INDIANA DEPARTMENT OF TRANSPORTATION

STANDARDS COMMITTEE MEETING

FINAL DRAFT MINUTES - REVISED

November 20, 2008 Standards Committee Meeting

INDIANA DEPARTMENT OF TRANSPORTATION	
UNDERDRAIN DETAILS	
JANUARY 2000	
STANDARD DRAWING NO. E 718-UNDR-01	
DESIGNED BY No. 18055 DATE 1-02-00	CHECKED BY No. 18055 DATE 1-02-00
DRAWN BY No. 18055 DATE 1-02-00	
CHECKED BY No. 18055 DATE 1-02-00

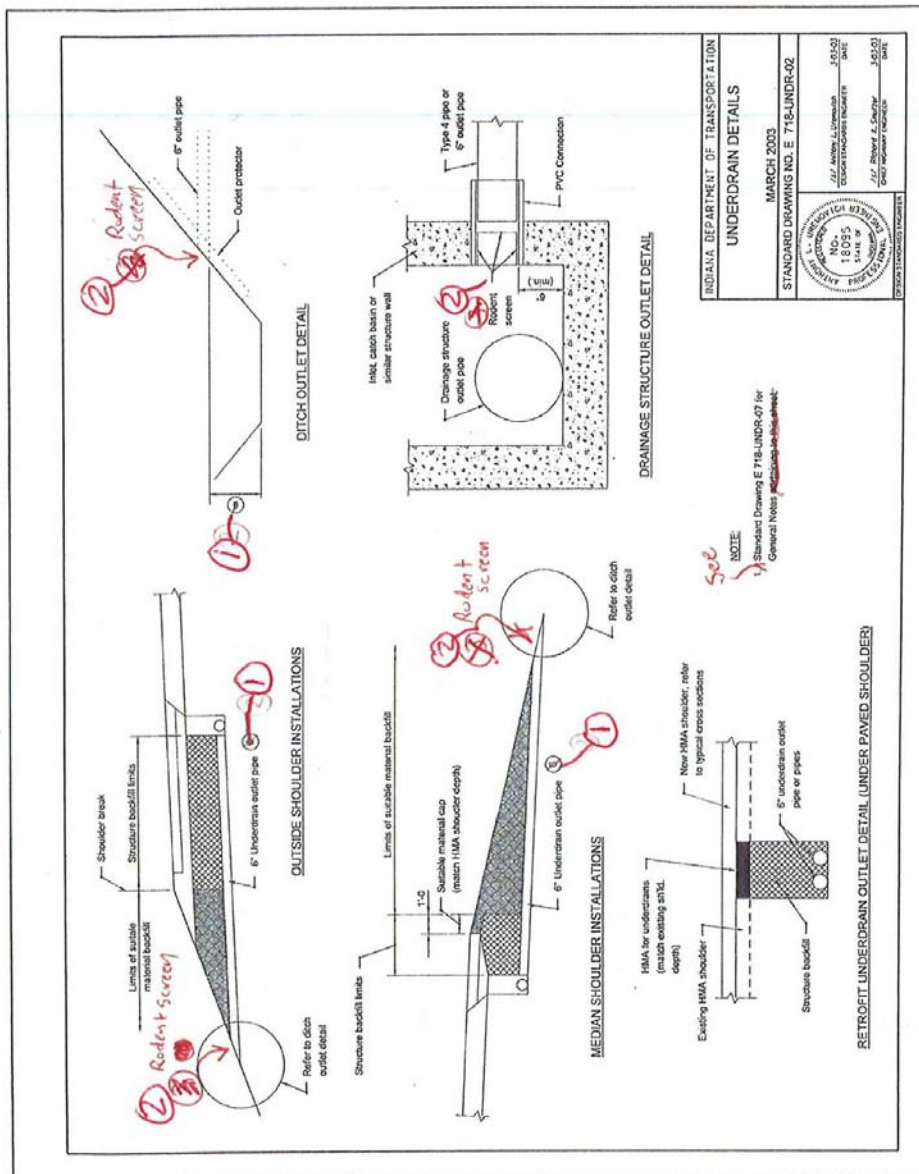
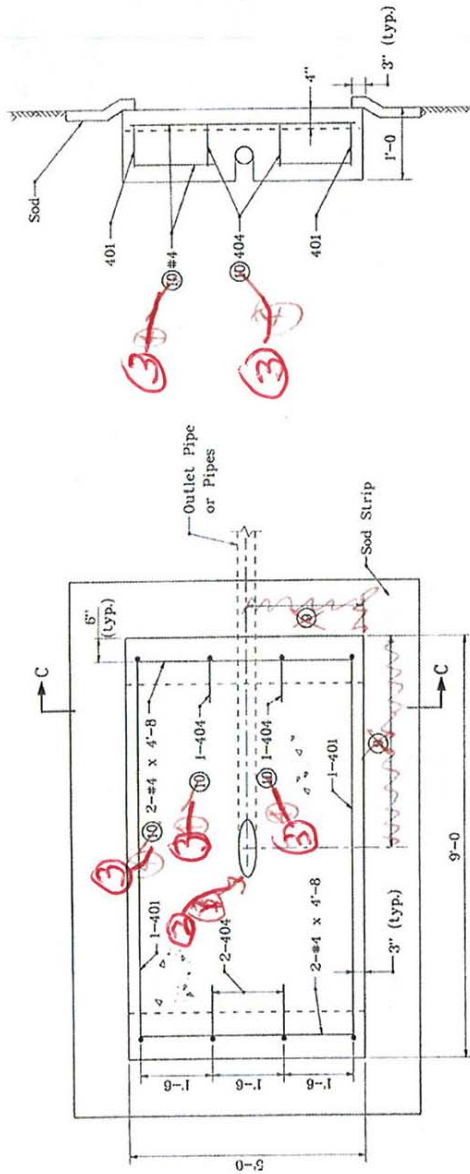
PROBLEM(S) ENCOUNTERED: In February 2008, Pay Limit information was removed from Standard Drawing E 718-UNDR-01 and placed in the Standard Specifications. For consistency, General Notes on E 718-UNDR-07 should be revised to place appropriate information in the Standard Specifications.

PROPOSED SOLUTION: Remove specification related information from General Notes on Standard Drawing E 718-UNDR-07 and place in appropriate part of 718. Revise Standard Drawings E 718-UNDR-01, E 718-UNDR-02, E 718-UNDR-03, E 718-UNDR-04, E 718-UNDR-05 and E 718-UNDR-07 to reflect changes.
